INCH-POUND
MIL-C-25955(USAF)
AMENDMENT 4
31 January 1994
SUPERSEDING
AMENDMENT 3
5 February 1960

MILITARY SPECIFICATION

CONNECTORS, ELECTRICAL, ENVIRONMENT RESISTING,
MINIATURE, WITH SNAP-IN CONTACTS

FIGURE 1 Contacts.

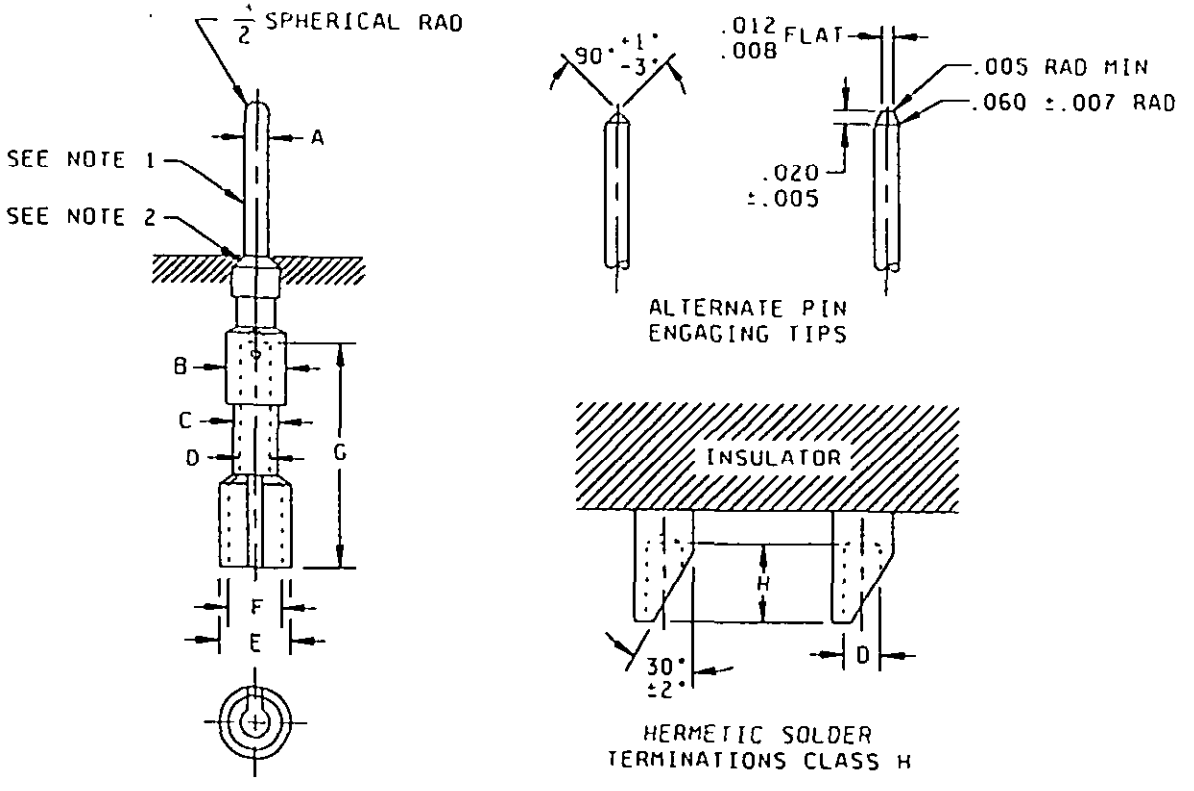
* FIGURE 1: Delete in its entirety and subsitute the following:

A ±.001	B Max	C Max	D Min	E Max	F Min	G ±.015	H ±.016	Contact size
.040	.085	.067	.042	.115	.082	.321	.109	20

NOTES:
1. Socket engaging end as necessary. Socket termination identical to pin termination.
2 Insert contacting and snap-in surfaces as necessary."
